# Fuel Cell System Cost for Transportation—2008 Cost Estimate

## Independent Review

# Independent Review Panel Summary Report

From: Independent Review Panel, Fuel Cell System Cost for Transportation – 2008 Cost Estimate  
To: Dr. Michael A. Duffy, NREL, DOE Hydrogen Systems Integrator  
Subject: Independent Review Panel Report

**Figure 1. Argonne National Laboratory PEM system model used by TIAX for the cost analysis**

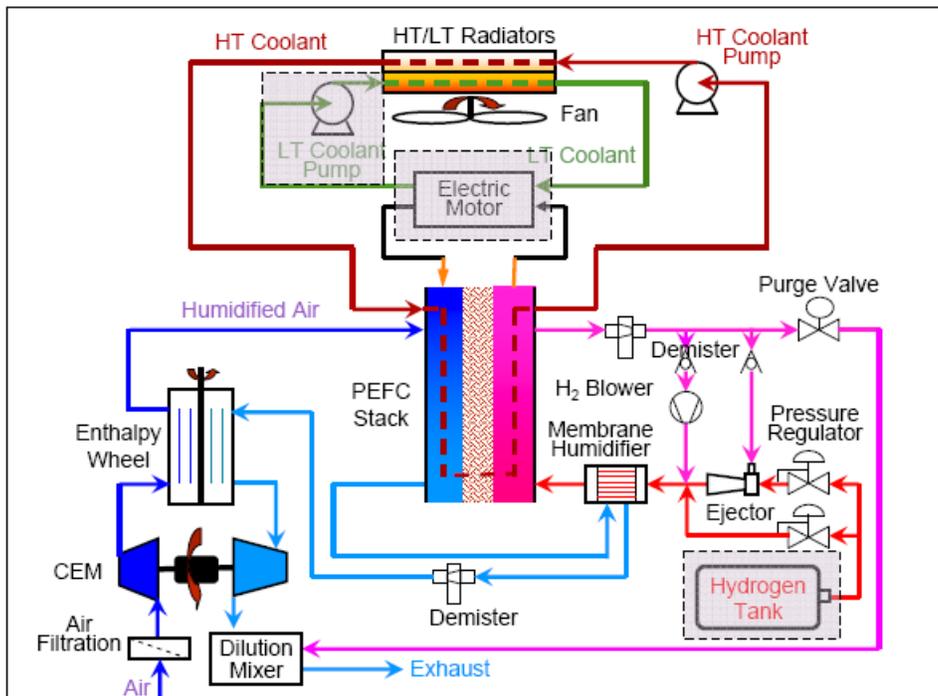
The fuel management subsystem has a hydrogen blower as a major component and two ejectors (see Figure 1). TIAX estimated the cost of the hydrogen recirculation blower based on published information and patents on the Parker Hannifin Model 55 Univane™ rotary compressor. TIAX used the DFMA software to apply its bottom-up approach. The projected cost of the hydrogen recirculation blower is \$193 per unit at a production rate of 500,000 units per year.

The water management subsystem identified by TIAX is not considered representative of today's technology or future PEM technology by the industry experts and the Panel. The major components of the water management subsystem are the EWH and the membrane hydrogen humidifier (MH). The major technical issue is with the EWH; based on industry interviews and FCTT, no fuel cell OEM uses the EWH to humidify the air. The EWH is introduced to the system via the ANL model and has the advantage that the air exiting the CEM (see Figure 1) does not need to be cooled before it enters the EWH.

Figure 2. Flow schematic of the 80-kW<sub>net</sub> direct hydrogen PEM system model used by DTI for the cost analysis

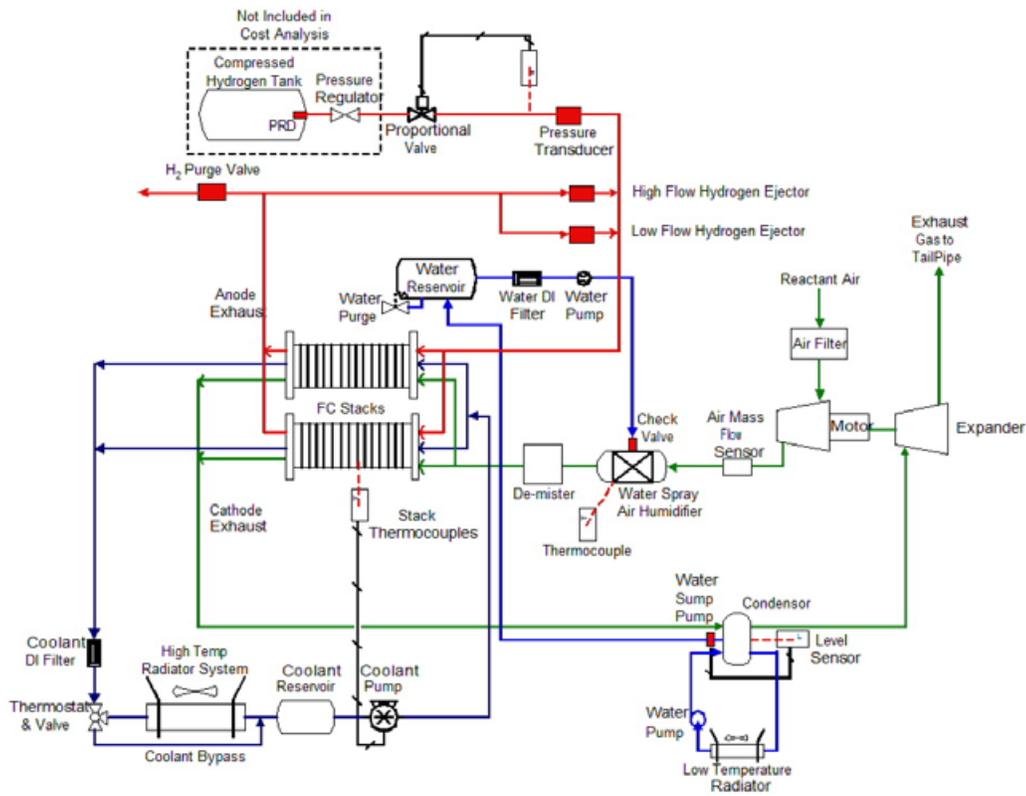
The overall system design (see Figure 2) was based on DTI's best approximation of the state-of-the-art technologies and how these might be assembled to achieve a functional unit. DTI used no proprietary information on system design in its system. As a result, it does not represent any system currently in use or under evaluation by OEMs or their respective suppliers.

- A thermodynamically correct system configuration by DTI would improve its ability to select and size components, which would influence the overall cost analysis.

- DTI's use of a thermodynamically correct model for the system would enhance confidence in its analyses.
- The contractors should adopt a common, industry-accepted methodology for component cost analysis such as DMFA for more consistent future comparisons.

Figure 4. Ionomer cost projection

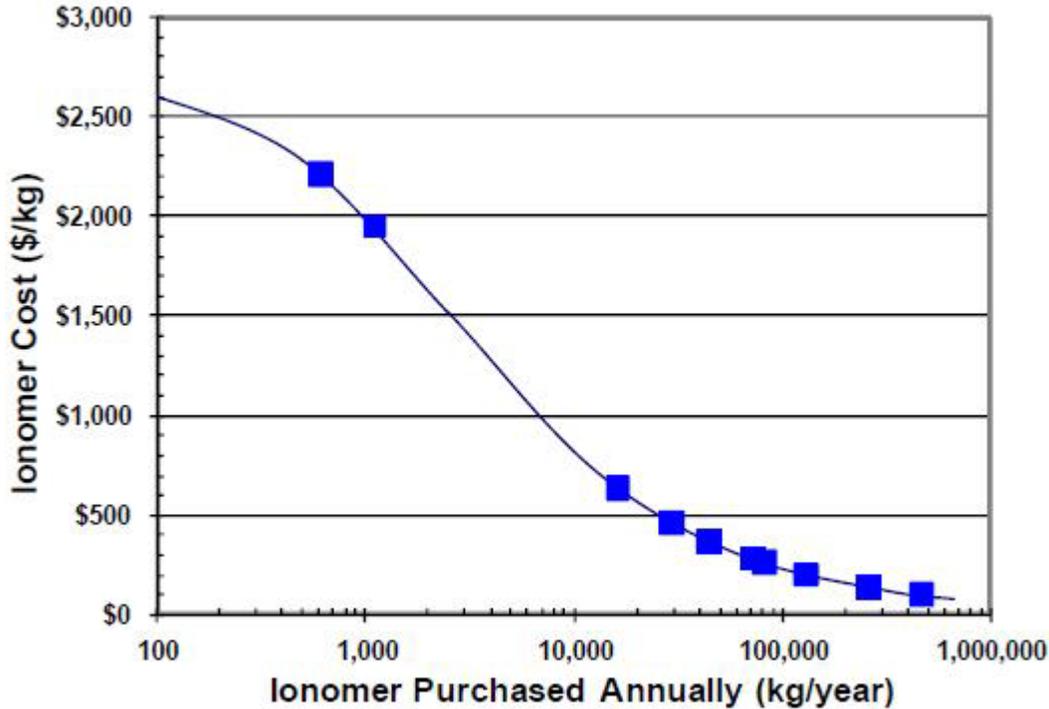
The cost assumed by DTI for Nafion in high volume (\$92/kg) is aggressive and perhaps fails to take certain key business factors into consideration. Even at high volume, the total production quantity for perfluorosulfonic acids (PFSA), including Nafion, will likely be less than 300 tonnes per year. Also, the tonnage for DuPont will be much less, as the overall market will be split between four or five companies.

If DTI's curve of ionomer cost reduction as a function of volume is correct (see Figure 4)<sup>14</sup> and if each supplier has about 50 tonnes/year of sales, the ionomer cost will be about \$400/kg. If the cost of manufacturing the membrane does not change, this analysis (if correct) would increase the membrane cost to approximately \$60/m<sup>2</sup> at 500,000 stacks/year. This is a significant difference from the \$16.62/m<sup>2</sup> estimated by DTI, which assumes that all membrane is produced by a single supplier.

**Figure 5. Roll processing process for depositing catalyst layers formed with edge seals using the decal transfer method; from 3M patent U.S. 7,195,690**

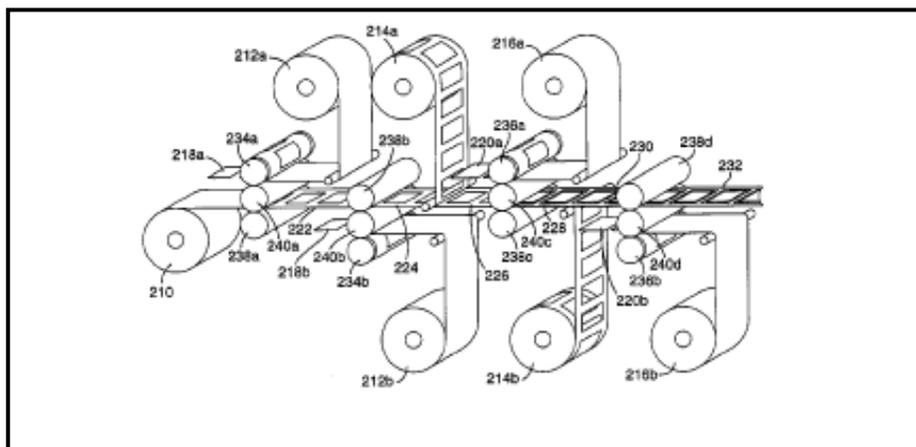
The continuous roll application of the catalyst layers will require a finite bonding period to hot bond the catalyst layer to the membrane that defines the production rate for the MEAs. TIAX did not identify the bonding period. Assuming 60 seconds as the rate controlling stage (two thirds of the hot pressing period<sup>20</sup>) for the hot bonding process and using the manufacturing criteria from the TIAX report,<sup>21</sup> 400 roll processing systems would be needed to meet the 500,000 systems per year production automotive requirements. Industry interviews identified that several production lines will be needed to reach constant state of manufacturing. The reproducibility of the 400 MEA manufacturing systems would need to be very high to meet the TIAX assumption of 100% yield.

TIAX did not discuss fabricating multiple MEAs with a wide membrane, forming a continuous, edge-to-edge coating of catalyst, and subsequently applying wide GDLs before slitting the wide MEA into rolls ready for die cutting. The concept of an edge-to-edge coated membrane may have technical difficulties with corrosion and shorting of the catalyst layers. Although the wide membrane with edge-to-edge catalyst coating may provide the highest production rate, the durability will need to be demonstrated.

The TIAX cost analysis assumes 100% yield for the fabrication of the MEAs without quality control measurements. Discussions with industrial manufacturers that use either the continuous or semi-continuous process did not validate the TIAX 100% yield assumption. They recognize that quality control is a major problem. Membrane and MEA production using traditional processes will have to change because the quality requirements will need to be greater than six sigma. Based on industry input, quality control would not be a major cost factor but could be as high as 1% to 2% of the present cost, which is equivalent to the labor cost identified by TIAX. Industry and the Panel do not support the TIAX 100% yield assumption.
